# TOTALPAC® 3

## 211316 - Dry-Pipe Pre-Action Sprinkler Systems

Project Name: Webster University-**ISB**

PROJECT NAME: Webster  
University ISB  
LOCATION: St. Louis  
Missouri  
CLIENT PROJ. NO.: N/A  
WES PROJ. NO.: 607  
SPECIFICATION 211316  
SECTION: Dry Pipe Sprinkler  
System  
SUBMITTAL ITEM: See Below -

**Figure 3 – Cabinet clearance dimensions**

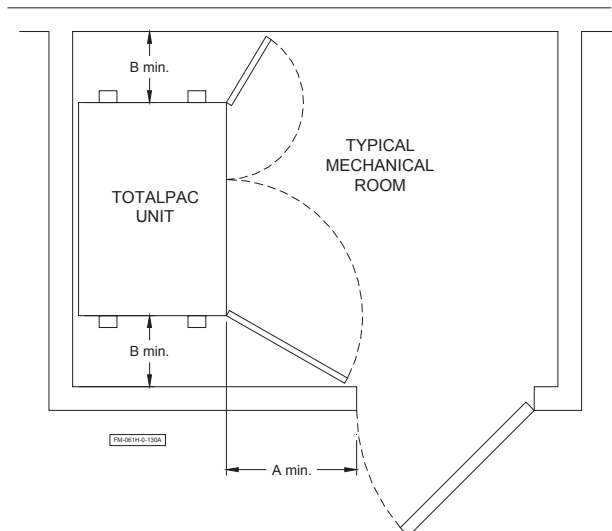
Cabinet is to fit with the space provided and maintain manufacturers recommended clearance requirements.
